**Lee County Board of County Commissioners
Agenda Item Summary**

Blue Sheet No. 20060695-UTL

**LEE COUNTY CONSTRUCTION CONTRACT
CHANGE ORDER**

**Lee County Utilities
Pinewoods Water Treatment Plant Expansion
Design-Builder: Harn R/O Systems, Inc.**

From April 2004 Proposal
Figure 1
PINWOODS WTP RO EXPANSION
LEE COUNTY UTILITIES

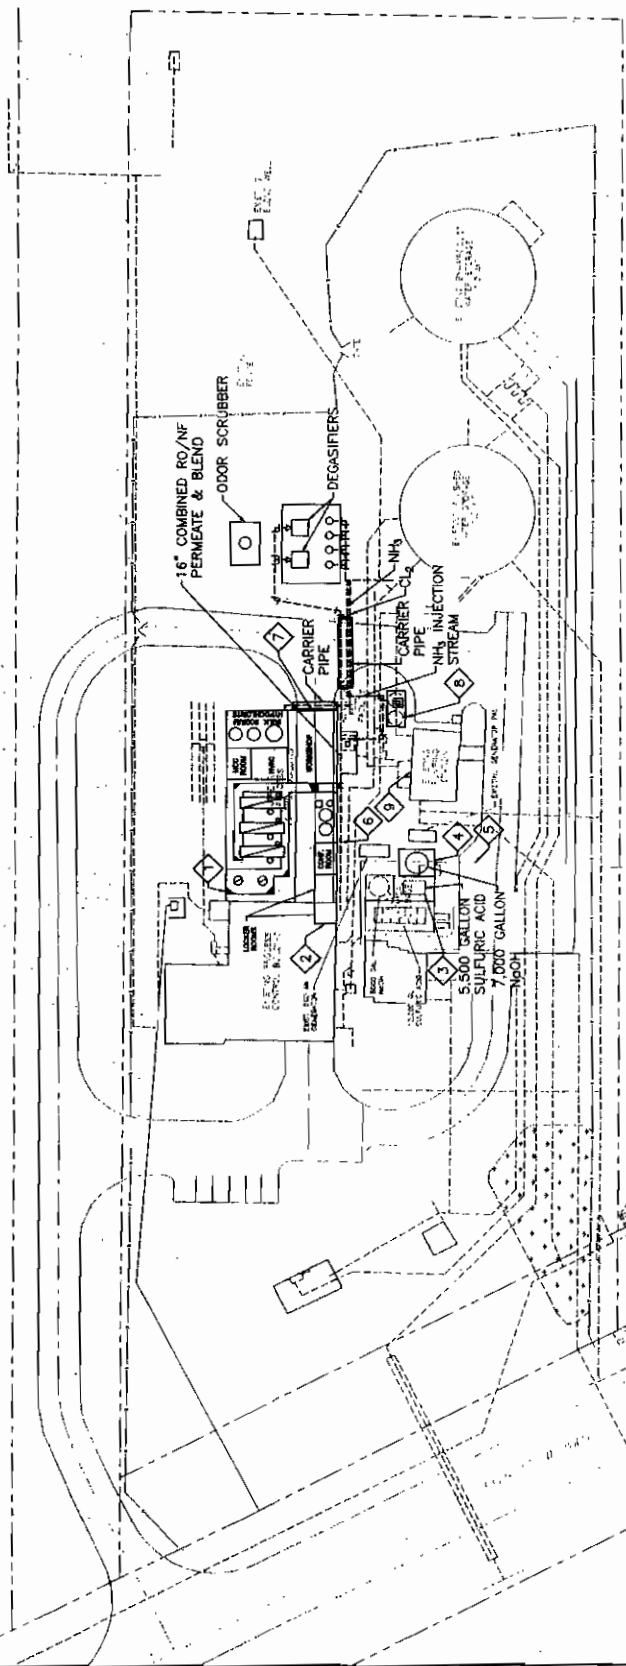
Proposal Basis	Current - proposed	Additional Cost
Yard Piping Associated with New 1 MG Finished Water Ground Storage Tank			
<i>Item 1.</i> 16" Finished Water Transfer Line to Tank, incl. above-ground inject/meter assembly <i>See Attached Breakdown</i>	Not Included	500 LF piping, fittings, valves, restraints, slab	\$218,187
<i>Item 2.</i> 12" Equalization Line between new tank and old tank <i>Eliminate</i>	Not Included	130 LF piping, fittings, valves, restraints	\$58,851 \$0
<i>Item 3.</i> 18" from new Tank, increasing to 24" and tying in old Tank, including injection assembly <i>Revised per Attached Breakdown, Deleting Injection Assembly</i>	Not Included	200 LF piping, fittings, valves, restraints, slab	\$163,766 \$113,276
<i>Item 4.</i> 18" to 24" from Tank to HSP suction, Piping and Valving, including metering assembly <i>Revised per Attached Breakdown, Reducing tie-in piping to 16"</i>	Tie into exist. 8" w/ 12" all above-ground	Buried & above-grade 24" piping, fittings, valving, supports, slab	\$392,416 \$370,559

16" Finished Water Transfer Line to Tank.....\$218,187 The piping should have been part of the work since a tank always require some type of connection. Please provide detailed cost for all components. (\$436/lf)

18" from new tank, increasing to 24".....\$163,766 the piping should have been part of the work since a tank always require some type of connection. Replace injection assembly as discussed. Please provide detailed cost for all components. (\$818/lf)

18" to 24" from tank to HSP suction.....\$392,416 the piping should have been part of the original work. Please provide detailed cost for all components.

<i>Revised Total</i>			\$702,022

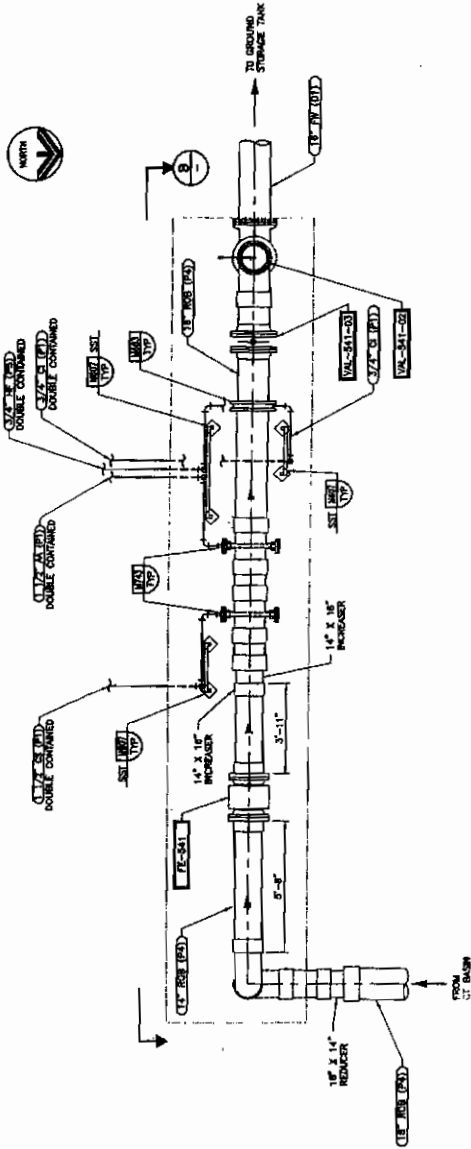
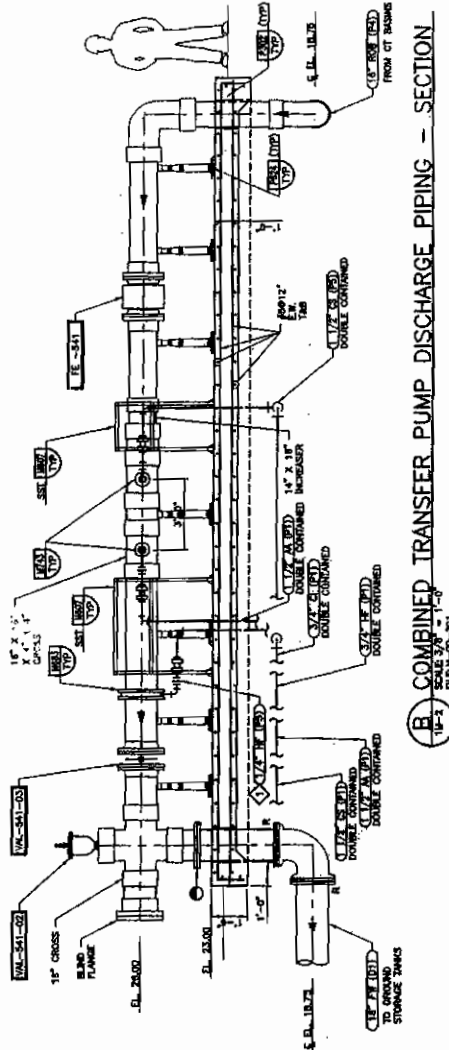
Breakdown
Delete
diffuser tap line corp. stop
16" instead 24"
